ACCELERATED DISTRIBUTION DEMONSTRATION SYSTEM

MONTICELLO NUCLEAR GENERATING PLANT  
DOCKET NO. 50-263 LICENSE NO. DPR-22

DESCRIPTION AND EVALUATION OF THE  
MODIFICATION TO THE 480 V BUS SUPPLYING THE LPCI INJECTION VALVES

## Figure 2

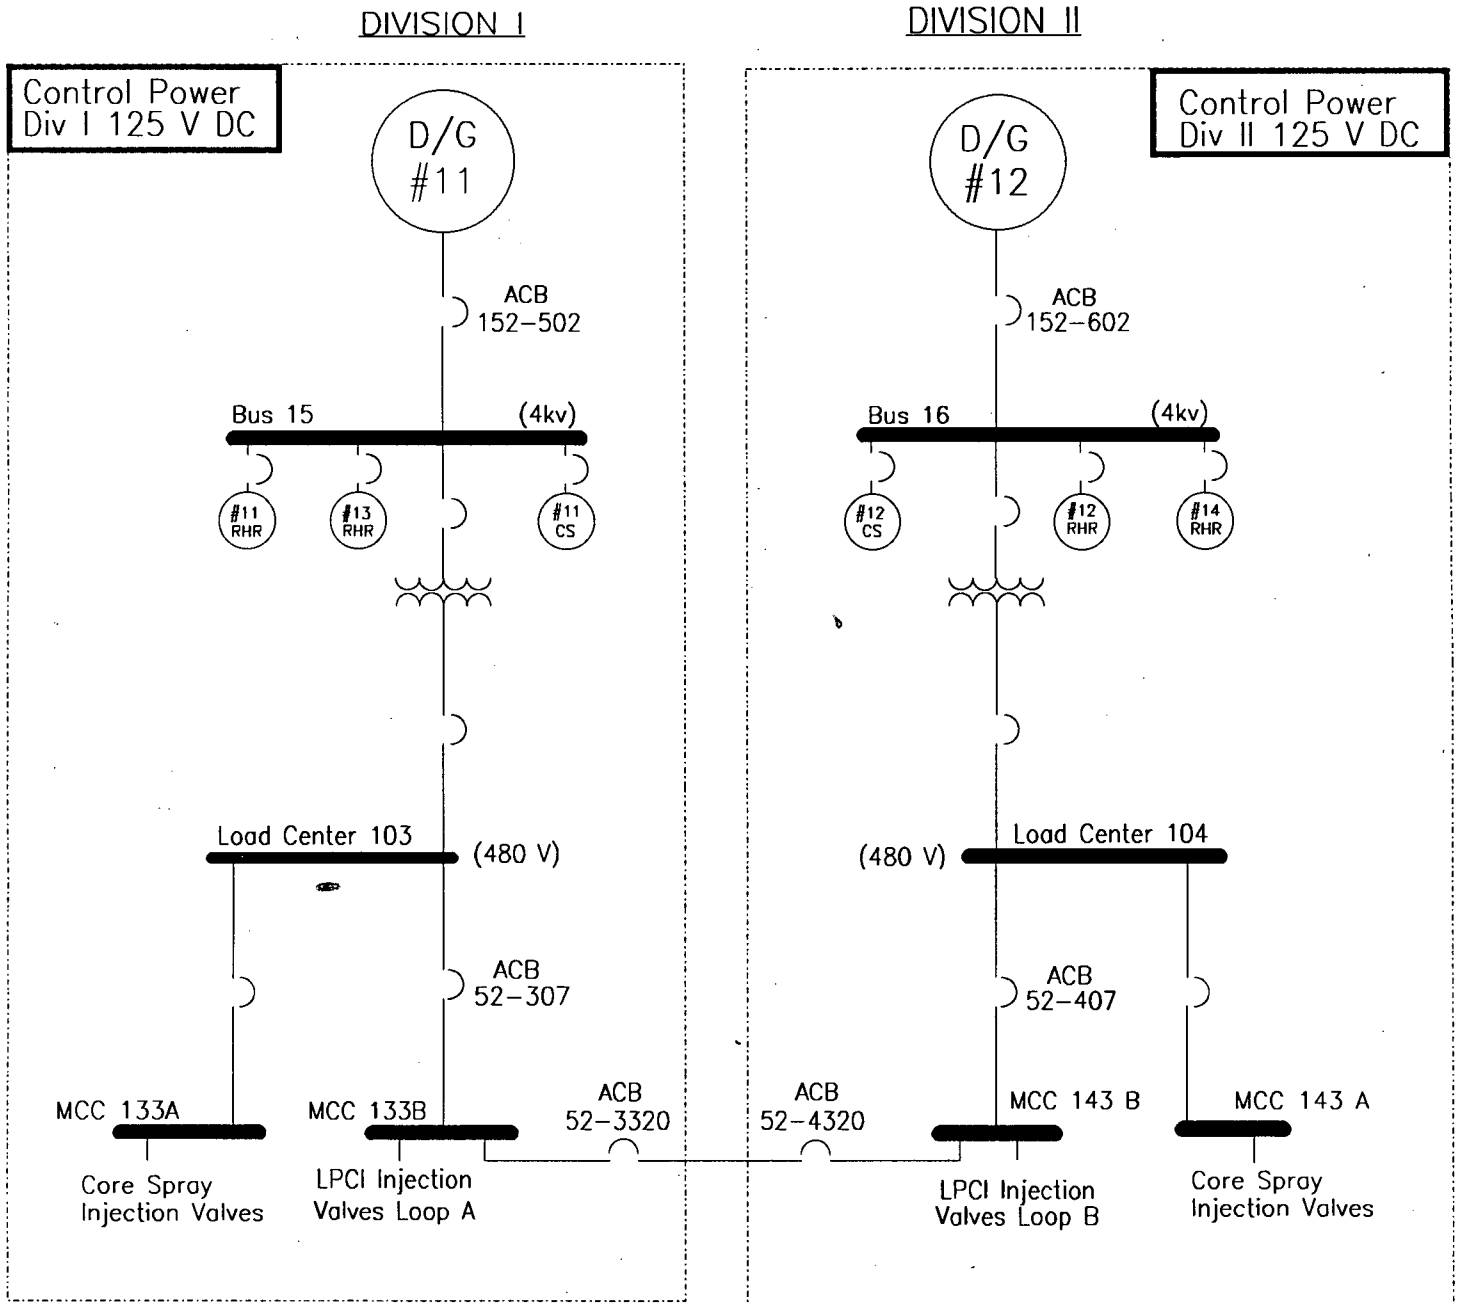
Figure 2 identifies the proposed modification to MCCs 133B and 143B. An additional source breaker will be added to MCC 133B and MCC 143B. This will provide two breakers with the capability of separating the load center from the motor control center. MCC 133B and MCC 143B will be "hard" wired together. The breakers that previously could tie MCC 133B and 143B together (ACB 52-3320 and 4320) will be removed and replaced with locked closed maintenance switches. Control power for Division I equipment will remain Division I 125 VDC. Control power for Division II equipment will remain Division II 125 VDC.

MCCs 133B and 143B will normally be fed from LC 103 with ACB 52-307 and 307A closed. The feed from LC 104, breaker ACB 52-407, would be normally closed and breaker ACB 52-407A normally open. The transfer from LC 103 to LC 104 would occur under the following conditions:

Paralleling of the two divisions will not be allowed. If both ACB 52-307A and 407A are closed at the same time, ACB 52-407 will be tripped separating the divisions electrically.

A no-voltage release device will be utilized to trip the ACB 52-307A after a loss of voltage for 10 seconds. This device will trip the breaker mechanically, requiring no control power.

The concern raised by the NRC Staff has also been resolved. Two breakers now separate the load centers and the MCCs supplying the LPCI injection valves (See Figure 2). LC 103 and MCC 133B are separated by ACB 52-307 and 307A. LC 104 and MCC 143B are separated by ACB 52-407 and 407A. Internal failure of a breaker or breaker control circuit will not cause the loss of both a load center and the MCC since the proposed design has backup breakers to sectionalize the failed breaker.
